# Attachment C: Proposed Changes to Ongoing Parklet Design Standards

## PALO ALTO ~~ONGOING~~PERMANENT PARKLETS PROGRAM

(Proposed modifications to the adopted standards)

**FIGURE 3: Dimensions of an Angled Parking Space Parklet**

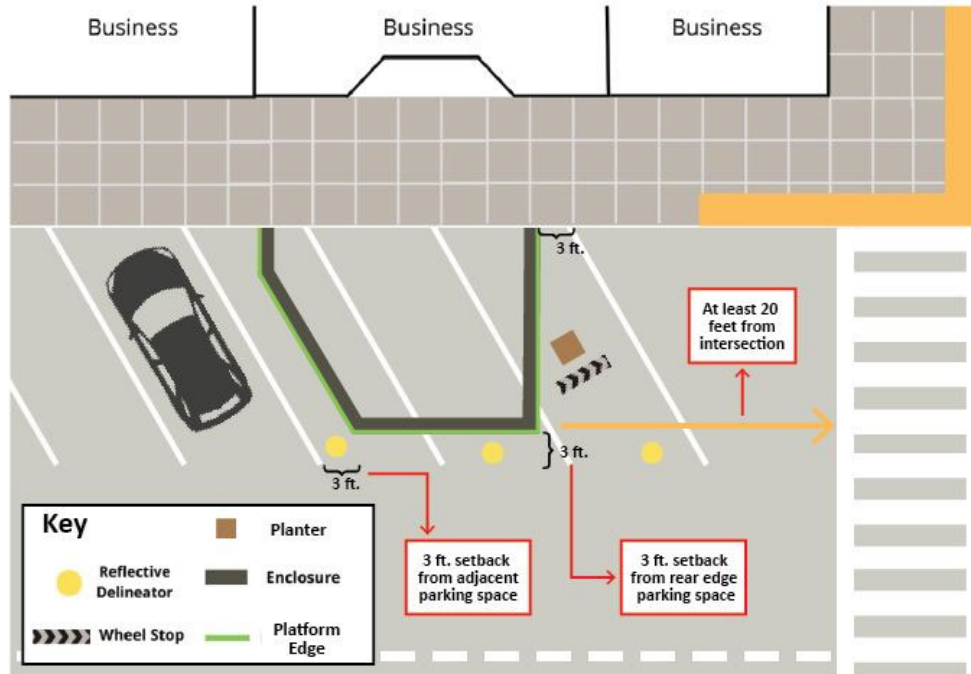
~~c.b.~~ A parklet platform shall be 3 feet back from the rear edge of the existing angled parking space. For angled parking spaces located on public streets within the City of Palo Alto, this shall be 3 feet from the exterior edge (closest to traffic) of the marked parking stall. This is shown in Figure 3.

~~d.c.~~ In no case shall a parklet be placed within the 3-foot area measured from the rear edge of the parking space. These 3 feet shall be kept clear at all times for emergency access.

~~f.e.~~ For angled parking spaces, the edge of the parklet must be set back 3 feet from the adjacent parking space on either space.

**FIGURE 7: Emergency Access Example**

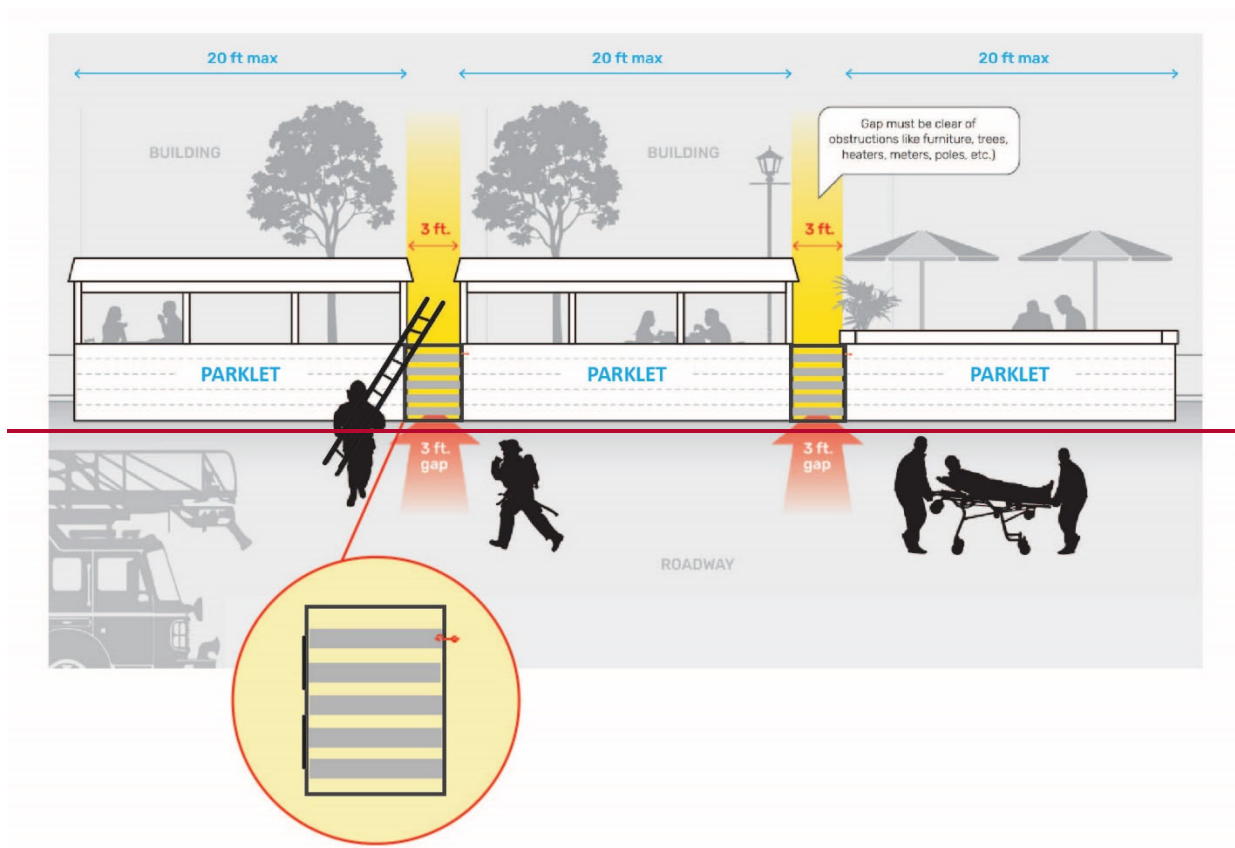
### 2. ~~Palo Alto Fire Department (PAFD) Emergency Access (Figure 7)~~

- a. ~~The PAFD may require a minimum 3-foot-wide emergency gap, with vertical and horizontal clearance, for every 20 feet of enclosure length.~~
- b. ~~The gap must be kept clear of any tables, chairs, bike racks, poles, walls, roofs, or other elements.~~
- c. ~~The barrier in the emergency access gap shall be easily removable by emergency personnel and provide a latch or hinge that allows easy access.~~
  - i. ~~The latch shall be placed on the outside of the barrier, facing the travel lane.~~
  - ii. ~~The hinge shall open a minimum of 90 degrees.~~
  - iii. ~~Any gaps in the barrier shall be smaller than a 4-inch sphere.~~
